DATE: December 1, 1997 Service Bulletin No. 505B (Supersedes  
Service Bulletin No. 505A) Engineering  
Aspects are FAA Approved

SUBJECT: Inspection of Crankshaft I.D. for Corrosion

MODELS AFFECTED: The following Textron Lycoming four cylinder engines which utilize fixed pitch propellers except those installed in rotary wing aircraft or new engines shipped after February 15, 1997:

Figure 1. Area to be Inspected

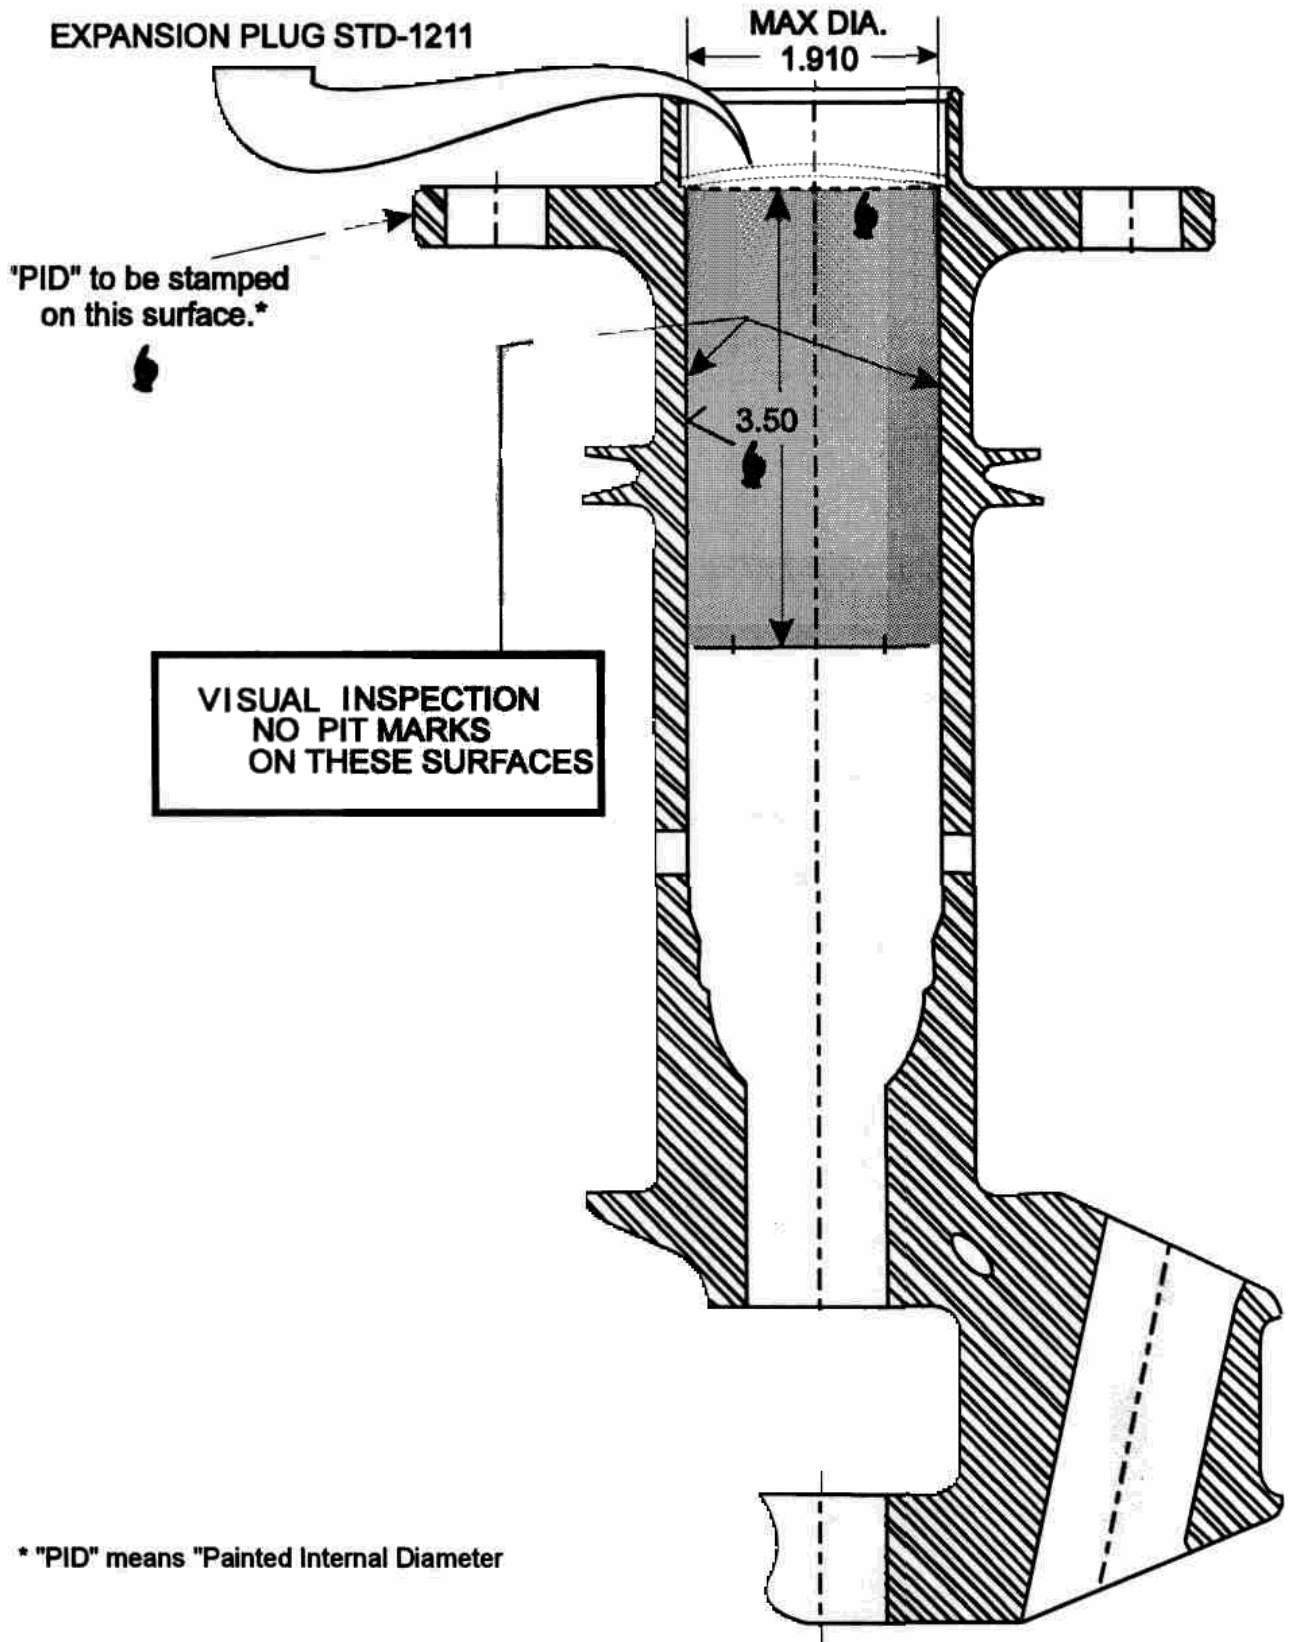
TIME OF COMPLIANCE: **Uncoated Crankshafts (no "PID" stamped on flange OD, see Figure 1)**

- a. Remove the propeller in accordance with the manufacturer's instructions.
- b. Remove expansion plug (P/N STD-1211) (if installed) from end of crankshaft by piercing a 1/8" to 3/16" hole in center of plug.
- c. Measuring in from the crankshaft end, clean the first 3.50 inches of the inside crankshaft wall behind the expansion plug seat.
- d. Remove surface corrosion using a suitable tool which will follow the existing contour of the I.D. and fine abrasive cloth (see Figure 1). Prior to removing the corrosion, precaution must be taken to ensure that the material removed cannot contaminate the engine.

- e. Make a visual inspection from the crankshaft flange inward using a flashlight and magnifying glass (power 4x). A small, right angle, dental examination mirror might be helpful. The above defined area should be clear of pit marks and corrosion.
- f. If during visual inspection any pitting resulting from corrosion is found, the crankshaft must be removed from service immediately or subjected to FPI according to Section II of this Service Bulletin on page 3. Removal of corrosion results in a clean surface that may have an irregular appearance indicated by slight wavi-ness. This condition is deemed acceptable provided the maximum allowable diameter has not be exceeded. Pitting is characterized by holes or fissures of indeterminate depth and direction.

**CAUTION**  
SURFACE CORROSION MUST BE REMOVED UNIFORMLY FROM THE CRANKSHAFT I.D. BUT THE I.D. CANNOT EXCEED 1.910 INCHES.

Crankshafts with I.D. of 1.910 inches can only be cleaned with Scotchbrite or an equivalent. No additional material may be removed.
